ITS CORPORATION			REV	ECN	DATE	APV
THIS PRINT IS THE PROPERTY OF ITS CORP. IT SHALL NOT BE COPIED WITHOUT PERMISSION.			TITLE			
			SCHMEMATIC, AMP./ATTENUATOR MODULE MMDS (1132-1509)			
MATERIAL			DWN	JCM	11/21/91	DWG. NO.
FINISH			CHK	JCM	11/14/91	1132-3509
			REL	JCM	11/14/91	REV
			SCALE ---		SHEET 1 OF 1

ITS CORPORATION				REV	ECN	DATE	APV
REV	ECN	DATE	APV	THIS PRINT IS THE PROPERTY OF ITS CORP. IT SHALL NOT BE COPIED WITHOUT PERMISSION.			
				MATERIAL			
				FINISH			
TITLE				SCHEMATIC – BROAD BAND CAVITY FILTER, 3 SECTION (1107–1101)			
DWN		JEO	6/27/88	DWG. NO.		REV	
CHK		RE	6/29/88	1107–3101		0	
REL		RE	6/29/88	A	SCALE ---	SHEET 1 OF 1

ITS CORPORATION				REV	ECN	DATE	APV
THIS PRINT IS THE PROPERTY OF ITS CORP. IT SHALL NOT BE COPIED WITHOUT PERMISSION.				TITLE SCHEMATIC - TRANSMITTER CONTROL BD. (1510-1104)			
				DWN	KEF	3-28-94	DWG. NO.
MATERIAL				CHK	CAR	5/10/94	1510-3104
FINISH				REL	KEF	11/17/94	2
				SCALE ---		SHEET 1 OF 1

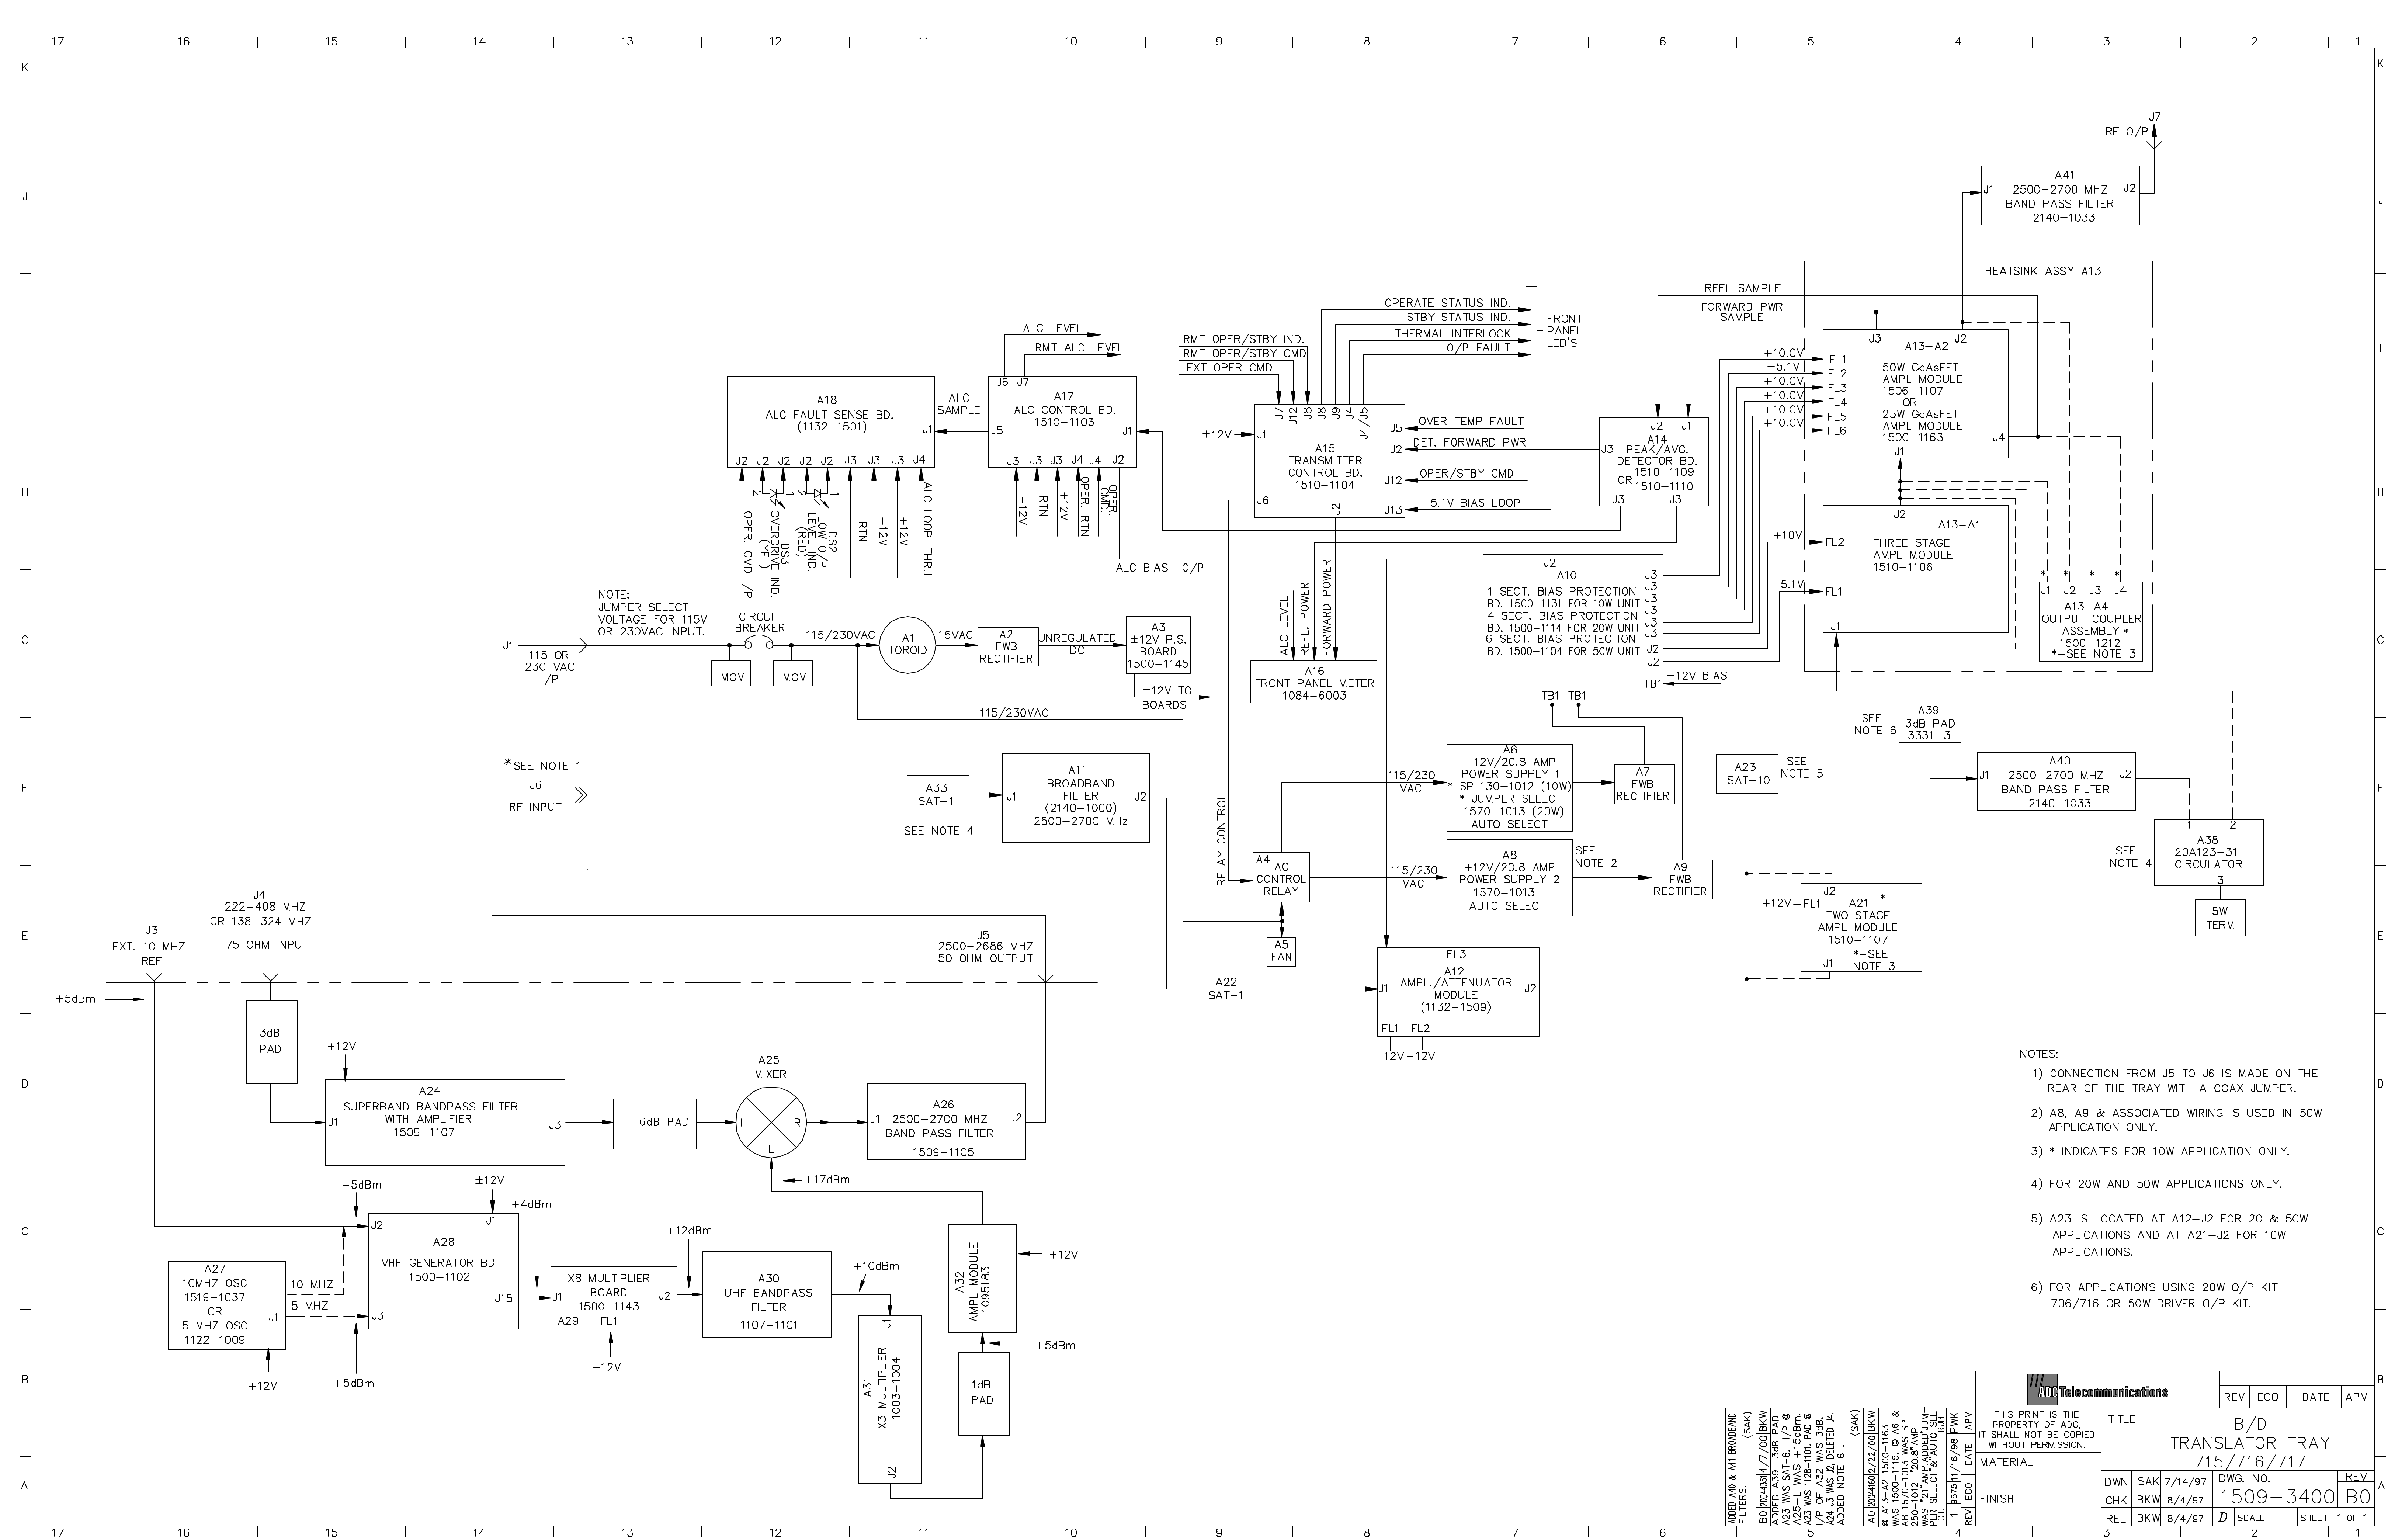
R1 WAS 220 OHMS, R8 WAS 120 OHMS. U1 & U2 WERE MSA-0885. (TMY)		3	4986	7/31/96	REF
DELETED 1/2W FROM R1 & R5 AND NOTES FOR SMA J1 & J2, CHANGED C10 FROM 300pF TO 100pF, & ADDED C5 100pF, 5nH TO L1, & 20nH TO L5		2	L0148	10/9/95	CJP
DELETE C13, C14, L7, L8, & U3, CHANGE U1 & U2 TO MSA-0885, R8 FROM 220 OHM 1/2W TO 120 OHM 1/4W, R9 FROM 150 OHM 1/2W TO 51 OHM 1/4W		1	L0035	4/6/95	CML
REV	ECN	DATE	APV

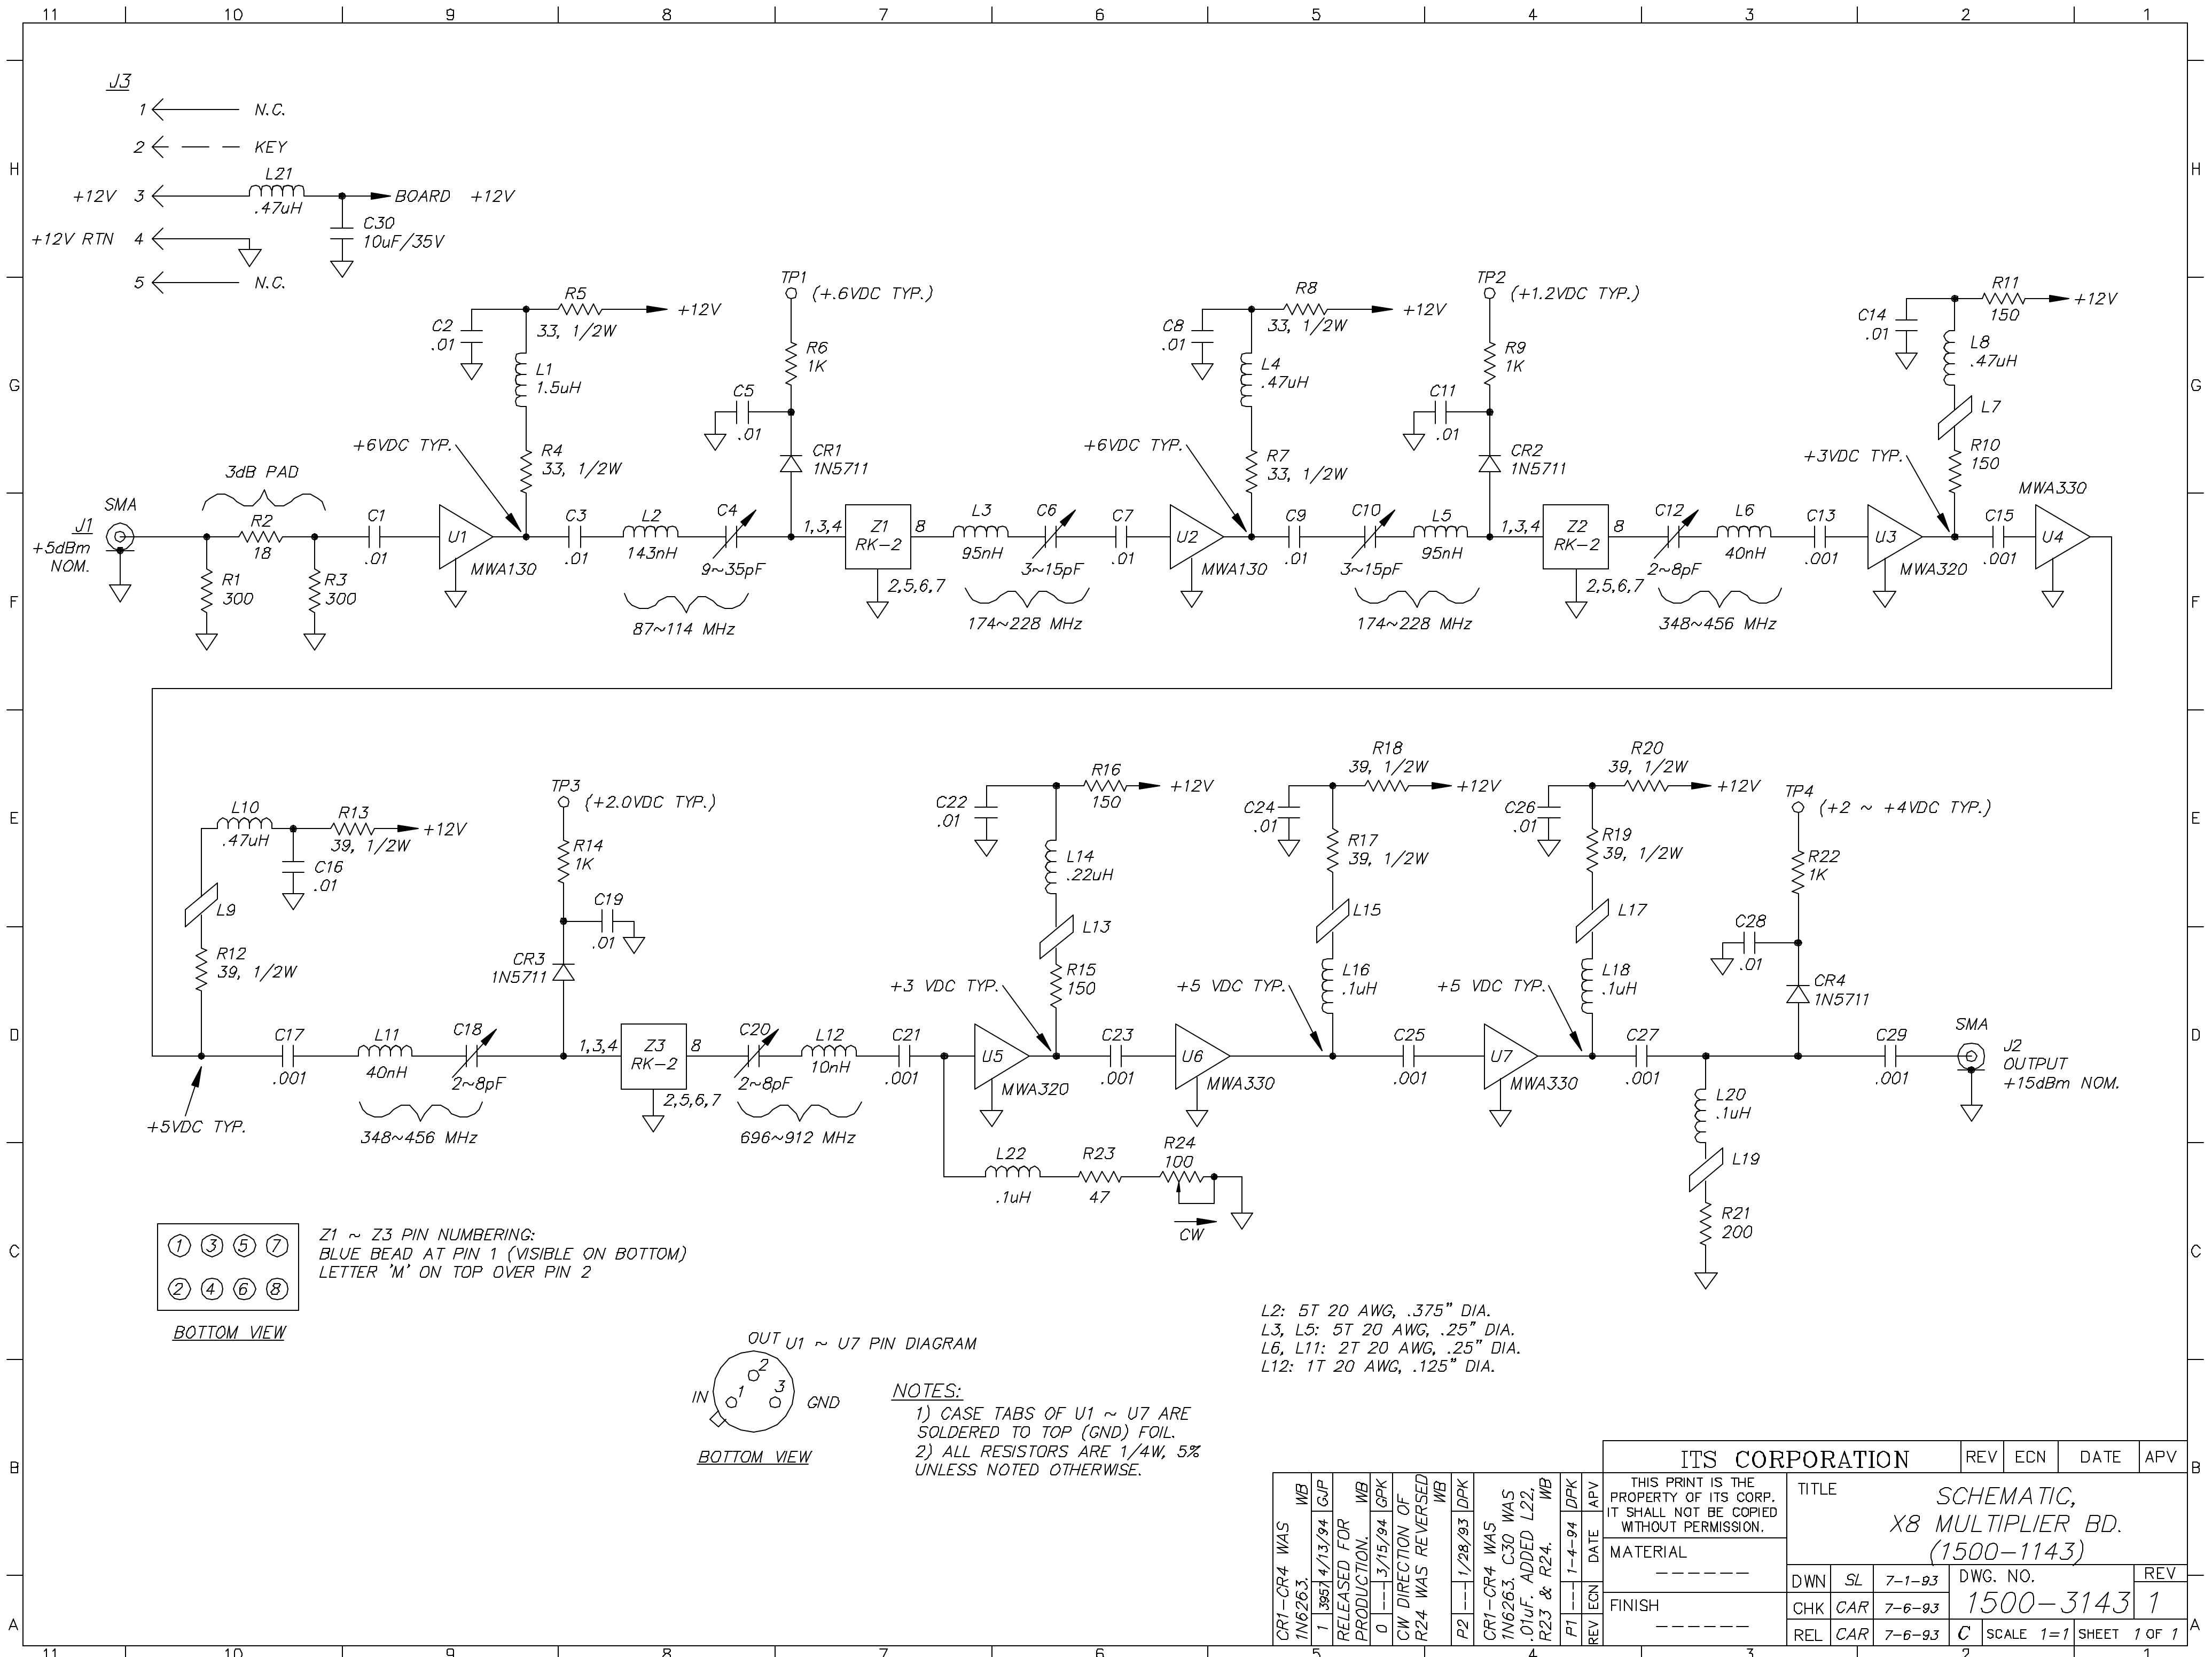
CR1-CR4 WAS 1N6263.				1 1395 4/13/94 GJP RELEASED FOR PRODUCTION.				WB 0 1 3/15/94 GPK CW DIRECTION OF R24 WAS REVERSED				WB P2 1/28/93 DPK CR1-CR4 WAS 1N6263. C30 WAS .01uF. ADDED L22, R23 & R24.				WB P1 1-4-94 DPK REV EGN DATE APV				THIS PRINT IS THE PROPERTY OF ITS CORP. IT SHALL NOT BE COPIED WITHOUT PERMISSION.				TITLE SCHEMATIC, X8 MULTIPLIER BD. (1500-1143)				REV	ECN	DATE	APV
DWN				SL				7-1-93				DWG. NO.				REV				1500-3143				1							
CHK				CAR				7-6-93				REL				CAR				7-6-93				C				SCALE 1=1			
																												SHEET 1 OF 1
